Title **PH 11 IN16P1 E CDDR5 1GB**

Title	RH JUNIPER LE GDDR5 1GB DP+DP/HDMI+2xDVI	Doc No.	105-C012xx-00B
-------	--	---------	----------------

## REVISION HISTORY

(15) Linear Regulators

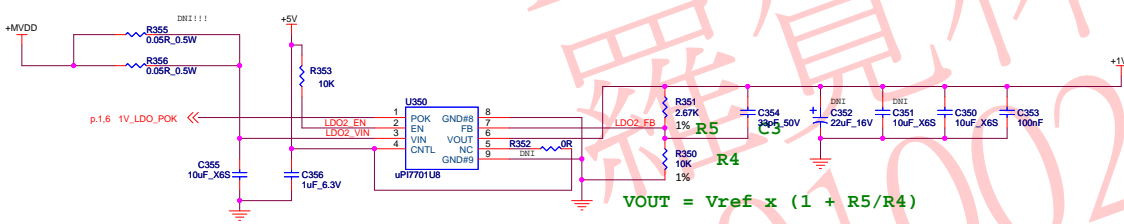
1.Change +5V REGULATOR to A1117

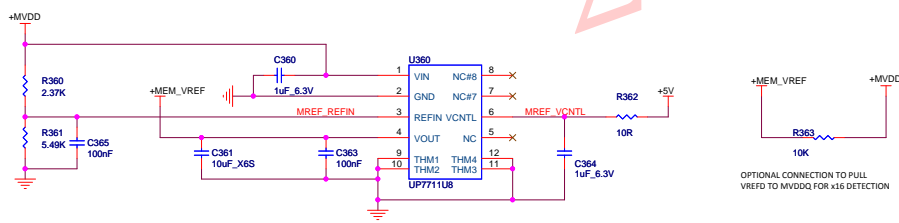
1.Removed BACKUP OPTION FOR +5V REGULATOR

(16) Power Management - Power Gating and External Power Detect

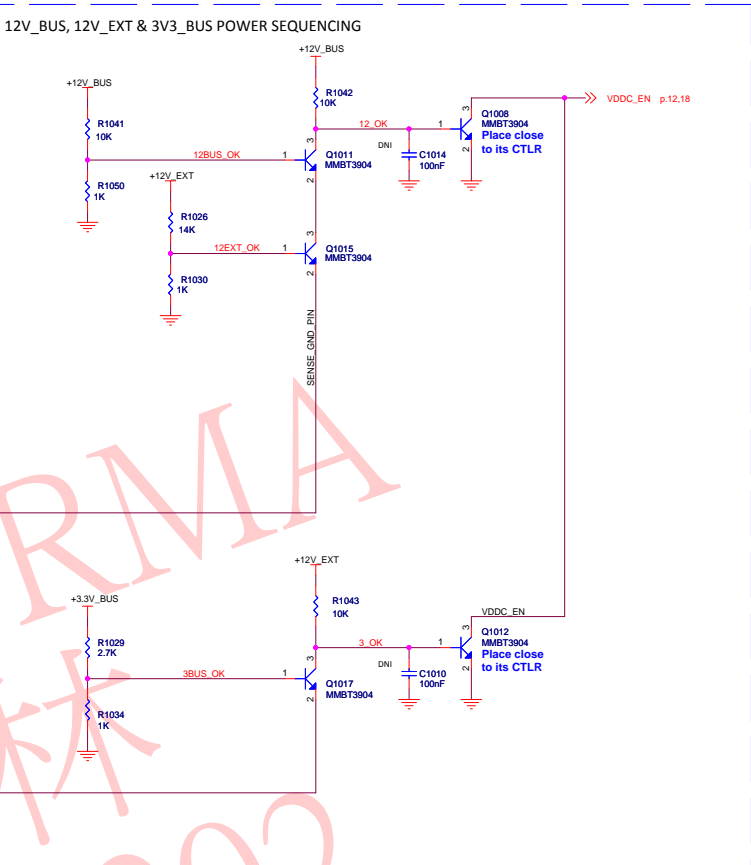
1.Remove option LED

(18) Power Management 2

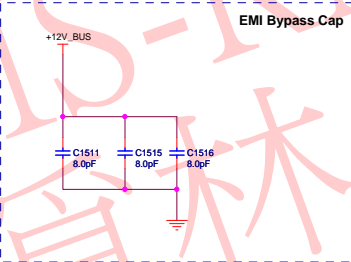
- 1.Removed I2C VOLTAGE REFERENCE FOR VDDC
- 2.Change input choke to .33uH from .47uH

## (19) Mechanical and Thermal Management

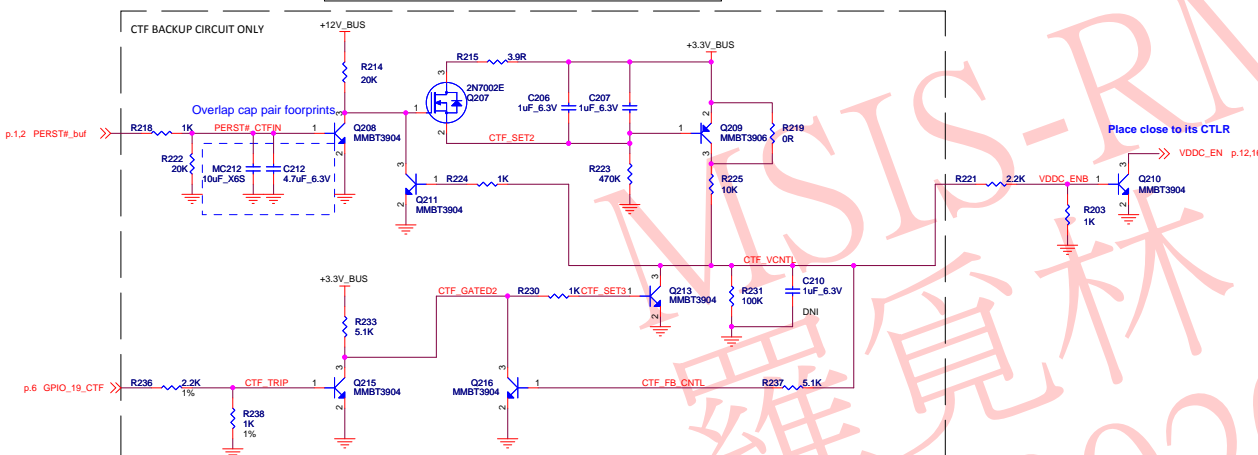
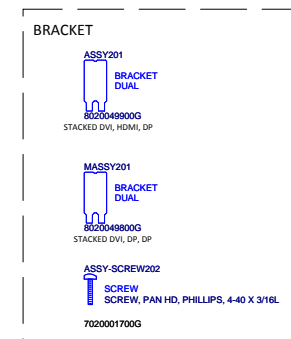
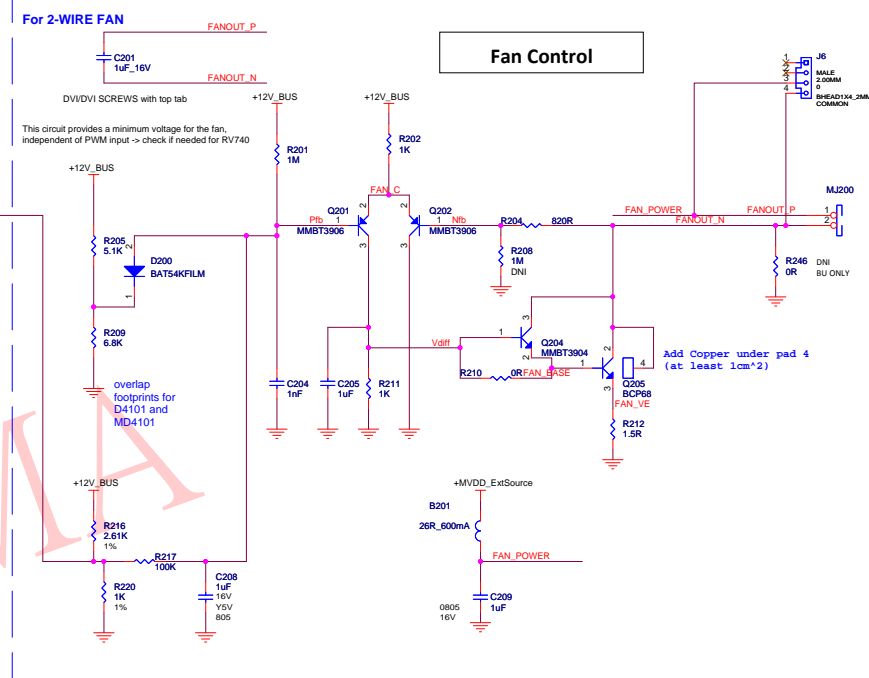
- 1.Remove CTF\_VCNTRL
- 2.Remove TCRIT and GPIO\_17\_ThermINT when LM96163 removed

### 1.Remove VDDC Thermal Protection

## (19) Debug Circuits

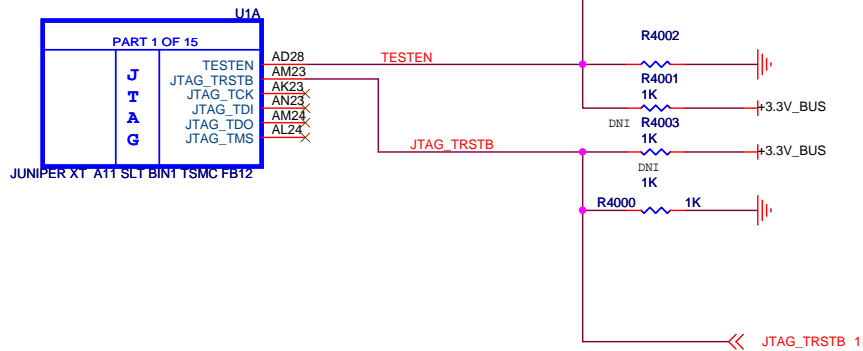
- 1.Remove LED RED "ON" shows Fault circuit
- 2.Remove JTAG and re-connect to PCIe RESET Buffered
- 3.Remove SWITCH CONNECTIONS TO PINSTRAPS
- 4.Remove LM96163
